MIAG and Mcl PC written submissions from oral presentation;

Issue Specific Hearings;

Traffic; Junction 24;

MIAG – Comments on re-designed Inworth Road Roundabout

Figure 5. Extent of 7% super-elevation that could be applied on the approach to Inworth Road Roundabout from Inworth Road north. (But requires an extension of 20m to the alignment).

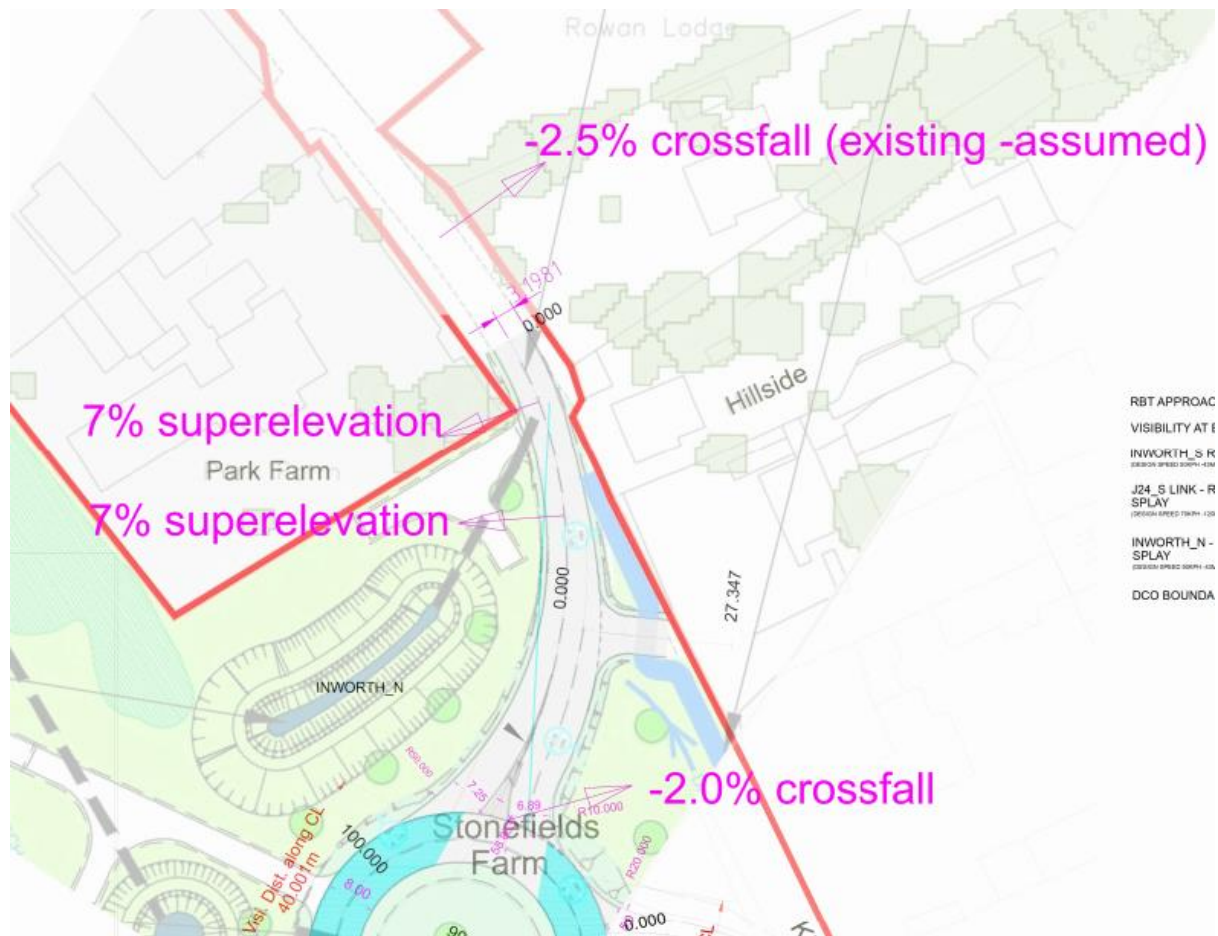
No approach straight has been provided for Inworth Road north arm at the tie in to the existing road. The minimum length of application of super-elevation was calculated to be 30.4 m, this being the shortest length of application and assumes a linear change in gradient of the outer channel and the road centre line of a constant 1% (a reverse curve profile could be used but would double the length of application to 60.8 m). Ideally an approach straight of about 20m length would need to be added to the alignment so that two thirds of the super-elevation can be applied before the beginning of the circular arc. Figure 5, below, shows the extents of the 7% super-elevation that can be applied on the approach to the roundabout.

At the roundabout end of the alignment +7% super-elevation would need to be reduced to -2% before the roundabout give way line. As the carriageway is wider at this end of the alignment the length of application of super-elevation will increase. The length to apply a change from +7% super-elevation to -2% cross fall at the give way line was calculated to be 47 m. This change in superelevation would occur mostly where the centreline horizontal radius is 75m and would leave less than 20 m length of this curve with the required 7% super-elevation. This is always a problem when approach arms to a roundabout are not designed with straight or near straight horizontal alignments.
